2. Information of Main Modifications after Issue of Service Manual

Note: Following modifications are already applied for the Europe version.

Fig. 11 Tuner P.C.B. Ass’y

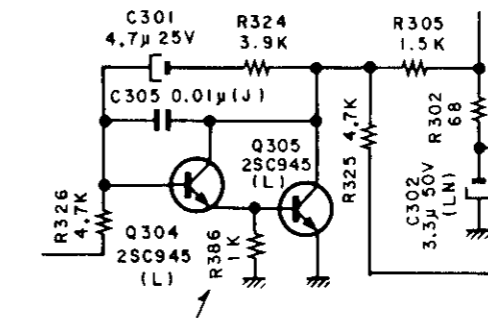
2.1. Improvement of FM S/N Ratio

R386 (1 K Ω) has been added between the base and emitter (GND) of Q305 on the Tuner P.C.B. Ass’y in order to improve the FM S/N ratio approx. 5 dB.

Added: R386 0B09667A Carbon Resistor
1K Ω 1/6W J

Fig. 12 CPU Control P.C.B. Ass’y

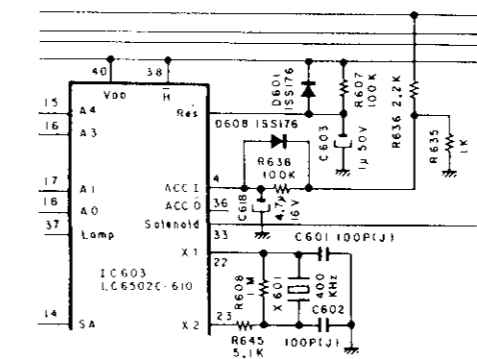
2.2. Modification of ACC Input Circuit

R635 on the CPU P.C.B. Ass’y has been changed from 2.2 K to 1 K. When a car without ACC position is used, ACC line voltage drops when the starter of the car is activated, resulting in erroneous CPU operation. To prevent this R635 has been changed.

Added: R635 0B01857A Carbon Resistor
1K Ω 1/4W J

Removed: R635 0B05622A Carbon Resistor
2.2K Ω 1/4W J

Fig. 13

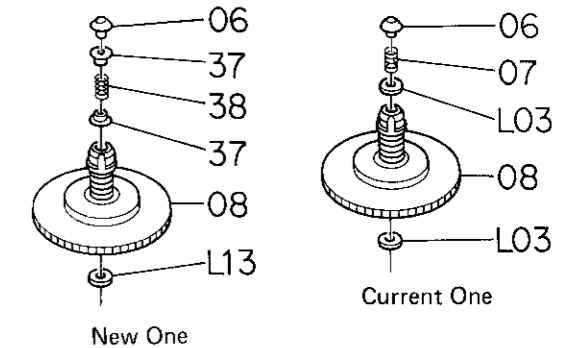
2.3. Modification of Back Tension

To obtain stronger torque and better wow/flutter characteristics, back tension spring and associated parts have been changed.

- 06: 0C08445A Reel Hub Cap
- 37: 0C08589A Tension Spring Sleeve
- 38: 0C08467D Back Tension Spring
- L13: 0E03132A Washer 2.1x6x0.25t

- 06: 0C08445A Reel Hub Cap
- 07: 0C08467C Back Tension Spring
- 08: CA08424A Reel Table Ass’y
- L03: 0E03061A Washer 2.1 mm
